DougLes Consulting Services Incorporated

April 14, 1999

Re: Owners of Strata #2720's buildings located at 545 Manchester and Durban St. Victoria, BC.

EXISTING BAND DETAIL

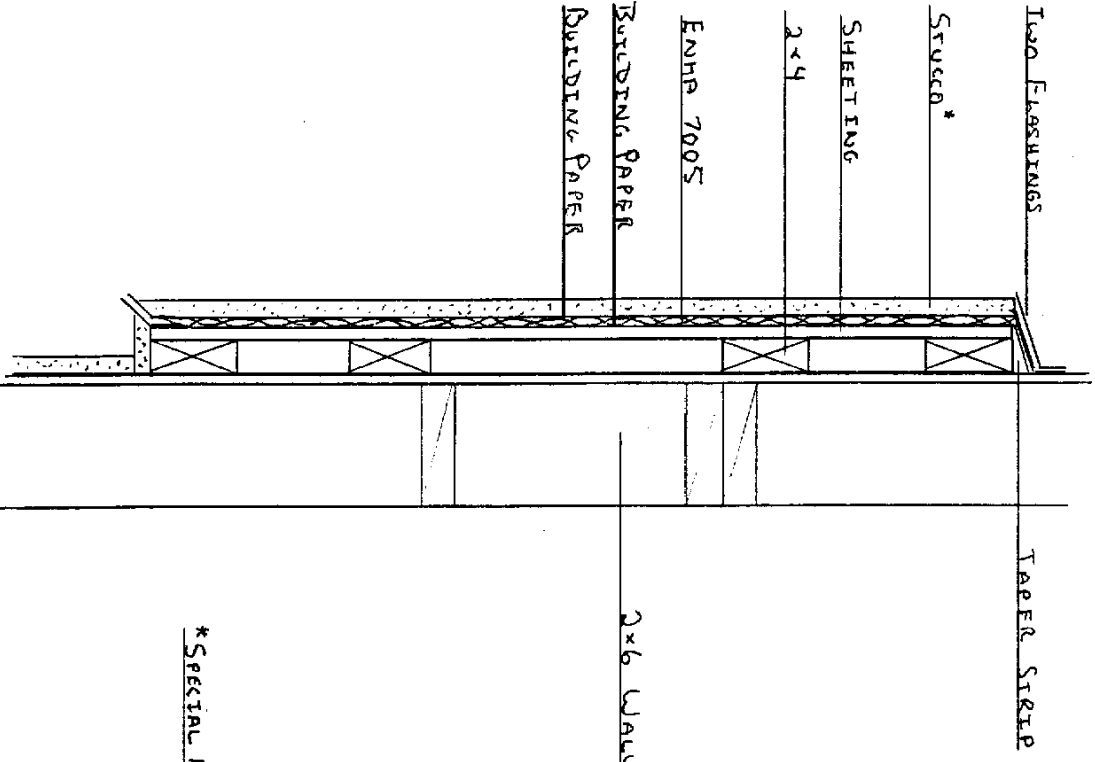
The decorative bands are a problem. They add details to the building including three bands of flashing to the entire perimeter. The bands are in close proximity to the bottom of the windows. The flashing profile at the windows was changed to allow for easy installation. The installation incorporated simple lap joints under each window. The lap joints rely on caulking to stop water. The continual expansion and contraction of the metal flashing has caused the caulking to break down and begin to fail. The flashing was installed with no slope. Settlement and shrinkage of the building has resulted in much of the flashing sloping back towards the building allowing it to hold water. Three solutions present themselves to contend with this problem

- 3) The band could be rebuilt to a new design (see design attached). This design would in effect address all of the problems with the bands, eliminate one row of flashing around the perimeter and allow water that is infiltrating above the bands to drain off the building at the band level, reducing trapped water and allowing some drying.

I trust that the above repair or maintenance options give the Strata the information required to take the next step. If there is something that is not clear or you required more information on please let me know. The final page is the design change for the decorative bands. Although not shown, part of this design would include lowering the top 2 x 4 to create more space between the band and the bottom of the windows. The top of this detail could also be used for the lower band.

PROPOSED BAND DETAIL
